TECHNICAL MEMORANDUM

To: Lake County Community Development Department

From: Annjanette Dodd, PhD, CA PE #77756

Subject: Seigler Springs North – UP 21-17– Revised Project Information and Response to Review of May 2023 Hydrology Report prepared for UP 21-17

Figure 1. Estimated radius of influence (distance) associated with the project's well (Threshold = 6-inches).

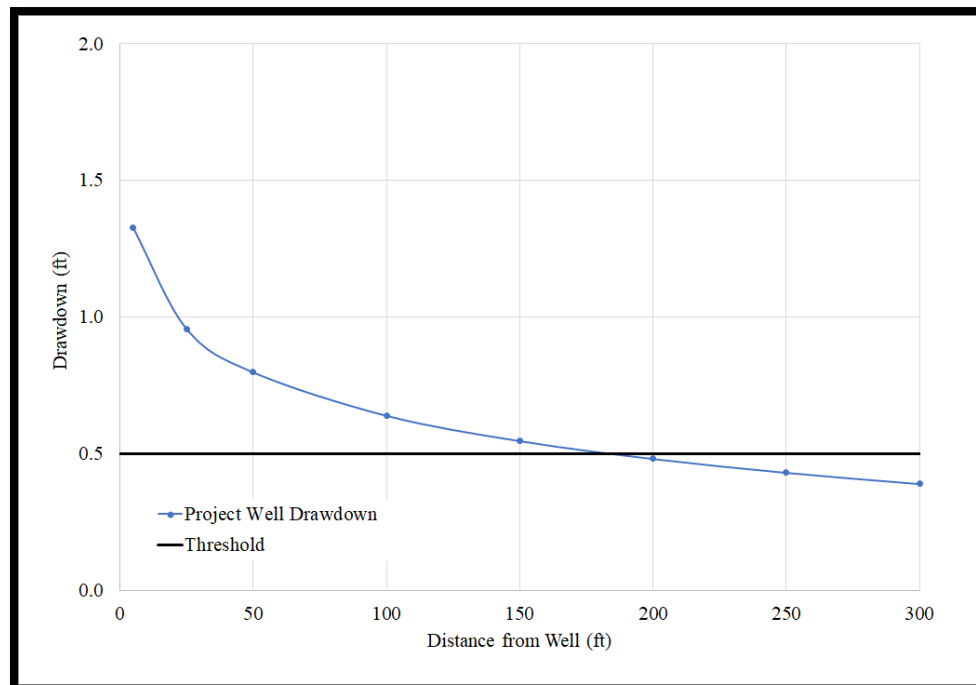
Geosyntec Comment #5: An adequate assessment of cumulative impacts to other water uses in the area was not provided. To provide an accurate assessment of cumulative impacts to the surrounding area, first the orientation and dip of the producing fractures must be known. This information can be obtained by use of the optical televiwer and heat pulse flow meter discussed for Comment 3. For example, if the producing fractures trend towards the northeast or southeast, then pumping on the proposed project well could have significant impact to the existing wells at the Mountain of Attention property.

Geosyntec Comment #5 Continued: In addition, until assessments are made on what the actual well capacity and aquifer recharge values are, operation of this well could dry out fractures in the area also resulting in significant impacts to nearby groundwater wells. Anecdotal information already suggests that fractures may be drying out and not being recharged. Attachment 4 provides two reports from adjacent properties. The first report is a summary of operations of four existing wells at the Mountain of Attention (Figure 1). As indicated in this report, pumping conducted years ago on a specific well (date not specified), supplied 80 gpm, 24-hours a day, 7-days a week. For a test conducted in July 2021, this well only supplied water at 80 gpm 6-hours a day before the well went dry. The well did recharge so that it could be pumped the next day. The second report is a memo from Timothy Toye, a local real estate broker, who indicates knowledge of two wells in the area that have dried up. Both of these reports strongly suggest that the system is being over pumped and not allowing recharge to occur.

Per Geosyntec's comment letter, The Mountain of Attention Sanctuary operated by the Adidam Holy Domains has multiple wells and the nearest well operated by the Mountain of Attention is located 2,921 feet to the west of the proposed project. The radius of influence of the project well was estimated using the Theis equation (Fetter, 2001). The Theis equation was developed to model the response of a confined aquifer to pumping. Using the Theis equation, the drawdown at a specific distance from each well can be estimated based on the project's maximum irrigation pumping

demand, 10 gpm, over a duration of 22 hours (Attachment 4). The radius of influence is the distance where the modeled cone of depression from groundwater extraction (drawdown) under these conditions is negligible (less than 6-inches), which is less than 200 feet from the project well (Figure 1), over 2,700 ft (0.5 miles) from the Mountain of Attention Sanctuary wells.

Response: Attachment 4 referenced by Geosyntec does provide enough information regarding the wells at Mountain of Attention and why they went dry. There are many reasons a well can go dry, construction issues, over pumping, maintenance, seasonal fluctuations, pump installation level, location, etc. Of the four existing wells at the Mountain of Attention, the report indicated that the other three wells are still working and providing water. Also, the wells are over 2,700 feet away from the project well. The information provided does not provide evidence that the project well would go dry. In addition, as discussed previously, the project proposes continuous groundwater level monitoring.

Figure 2. Screened well interval (SI) elevations and ground surface elevations.

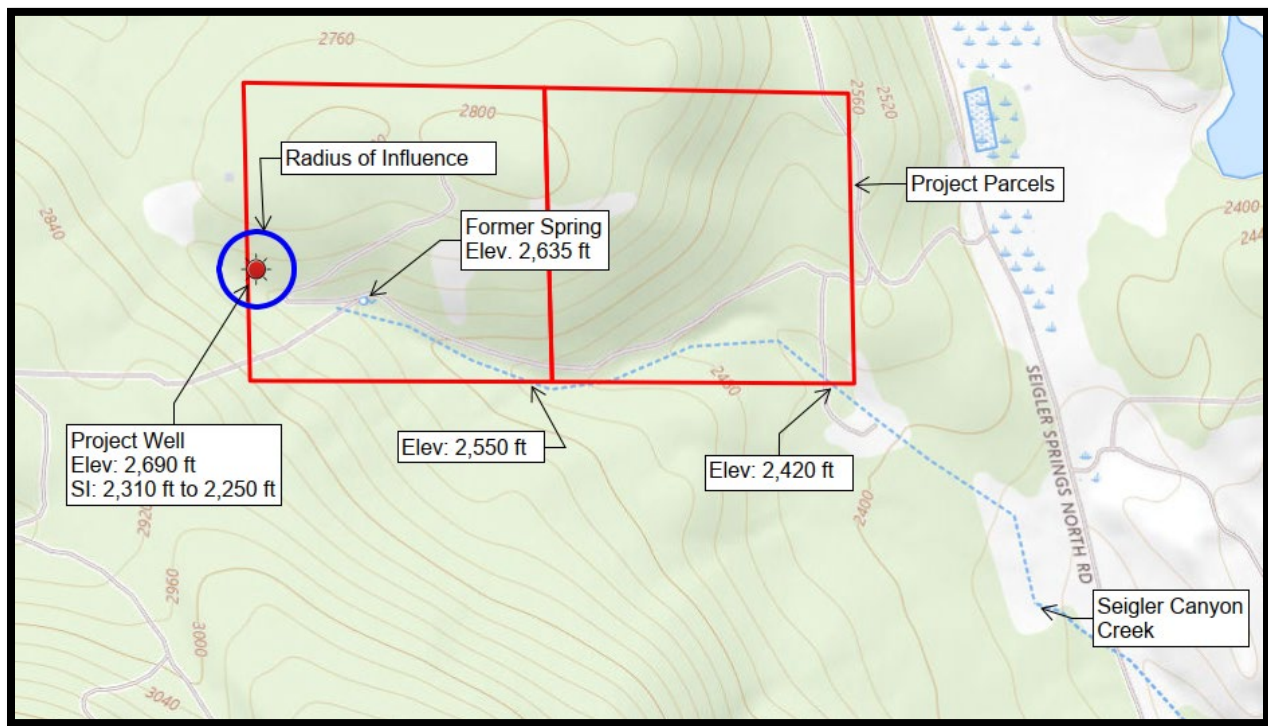
Geosyntec Comment #5 Continued: The report also did not assess the presence of springs in the area that could be sourced from this aquifer system. A map showing where springs are located and study to assess potential impacts to these features needs to be completed and if impacts affect surface water flows. In addition, the geologic map provided in the Northpoint report indicates there are faults in the area including one that goes through the project area. The impact on water movement from these faults should be assessed for this project.

Response: The USGS topographic maps indicate a spring approximately 500 feet west of the well. The Biological Resources Assessment prepared by Natural Investigations (dated November 2020) for the project did not identify any springs on site and stated that, “a spring is indicated on the USGS topo map, but no spring could be found at the top of the watercourse”. That being said, the location of the spring is located outside of the radius of influence of the well. The surface elevation of the spring is approximately 325 feet above the screened interval of the well, which starts at an elevation of approximately 2,310 ft and ends at an elevation of approximately 2,250 ft, well below the elevations of the ephemeral streams in the vicinity of the project parcels (Figure 2). The project well extracts water from a confined volcanic water bearing unit, well below surface water, and is a non-diversionary water source.
